## 2011 Change Proposals - New Allowances (4 Items) Posted by joepaluch - 27 Oct 2010 06:04

#### 944-SPEC - 944SPEC - low cost wheel to wheel racing

2011-4.) Lexan rear Qtr windows

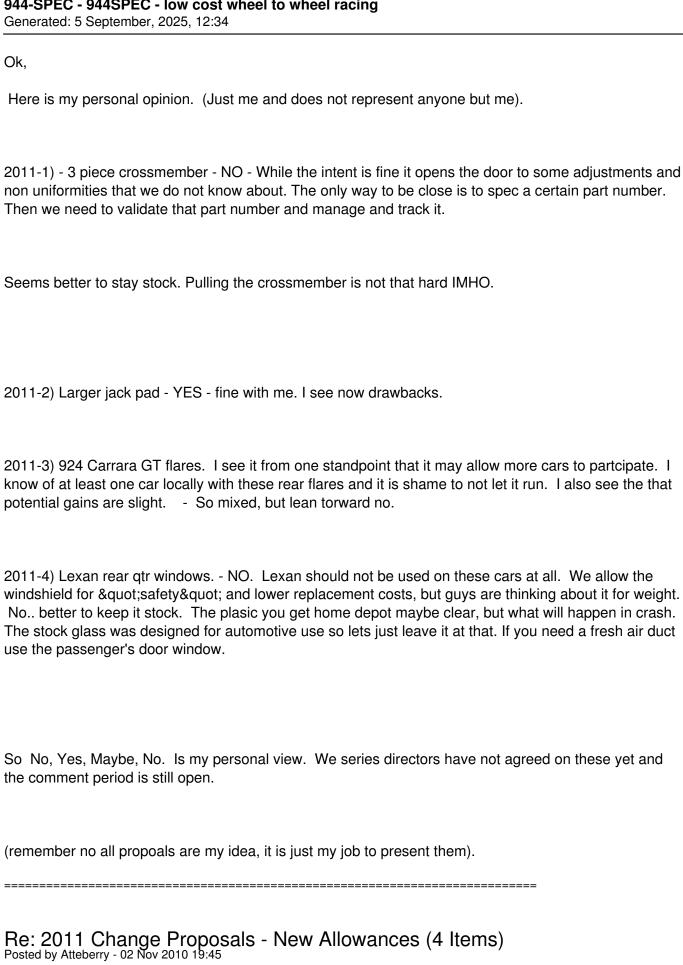
Proposal: Allow rear replacement of glass gtr windows with lexan and to allow air ducting to be installed in these lexan windows. No changes to rear hatch.

Justification: Makes it a nice clean way to provide fresh air ducting.
